# UNITED STATES PATENT AND TRADEMARK OFFICE

APPLICATION NO.	FILING DATE	FIRST NAMED INVENTOR	ATTORNEY DOCKET NO.	CONFIRMATION NO.
10/823,357	04/13/2004	Rick M. McCraney	36327-95396	4717

**Office Action Summary**

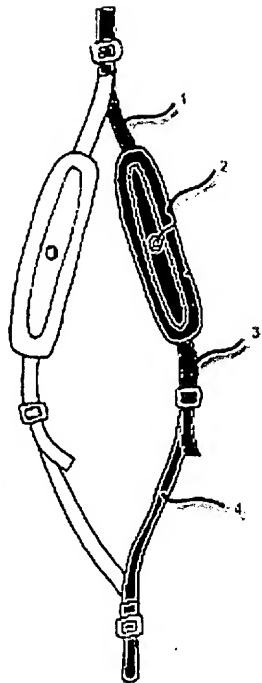
Regarding claims 7 and 8, the first strap of Kakouras includes the four claimed segments as set forth in the figure presented below. The first segment (1, below) includes the first buckle. The second segment (2, below) includes a pad (15). The fourth segment (4, below) is adjustably coupled to a third segment (3, below) and includes the second buckle.
